**ARENA RENOVATIONS
FOR
MIDLOTHIAN HIGH SCHOOL
MIDLOTHIAN INDEPENDENT SCHOOL DISTRICT**

**ADDENDUM NO. 1
APRIL 12, 2021**

DEMOLITION FLOOR PLAN - UNIT A - LEVEL 2 - ELECTRICAL

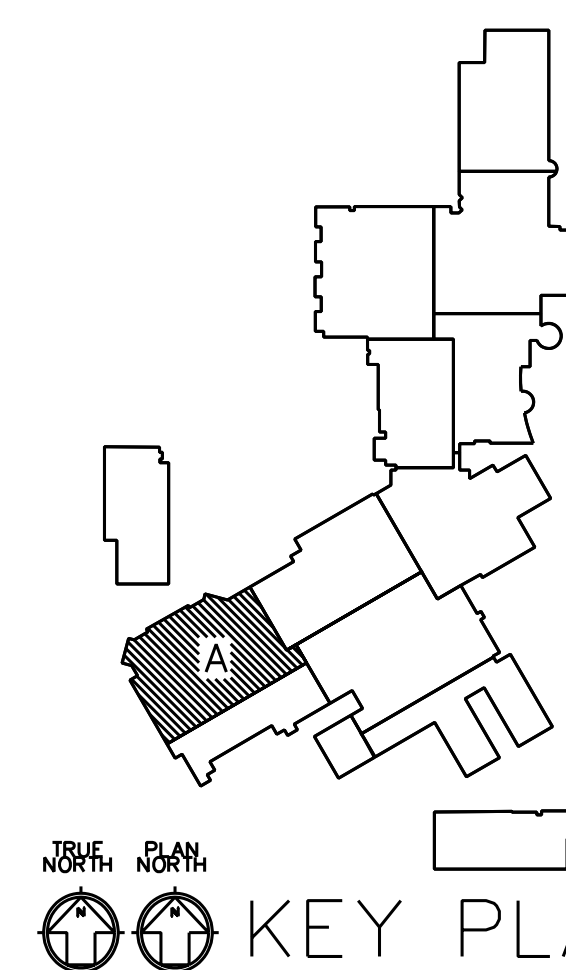
ITEM NO. 04 DE1.04:

- A. Revised General Demolition Notes.
- B. Added Notes By Symbols.
- C. Refer to attached sheet for revisions.

- ## NOTES BY SYMBOL 'O':
- 1) EXISTING LIGHTS SHALL BE DISCONNECTED AND REMOVED. REMOVE ALL ASSOCIATED WIRE, CONDUIT, WATERS, AND ELECTRICAL BOXES. ALL ROUND 4" DIAMETER FIXTURES IN CEILING HAVE A 48" DIA. BOX ABOVE. BOXES 12" TO 18" DEEP AND WILL NEED TO BE REMOVED WITH FIXTURE.
 - 2) EXISTING SCOREBOARDS SHALL BE DISCONNECTED AND REMOVED FROM CENTER HUNG CONDOLA BY SCOREBOARD INSTALLER. EXISTING POWER TO REMAIN. PREPARE POWER FOR REUSE.
 - 3) EXISTING CENTER HUNG CONDOLA FRAME TO REMAIN. SCOREBOARD INSTALLER TO CAREFULLY REMOVE AND REINSTALL EXISTING CENTER COVER/PANEL. PROVIDE PROTECTIVE COVERING TO STORE DURING CONSTRUCTION AND PREPARE FOR INSTALLATION.
 - 4) EXISTING LIGHT FIXTURE OVER STAIR WILL REQUIRE SCAFFOLDING TO REPLACE LIGHT FIXTURE.
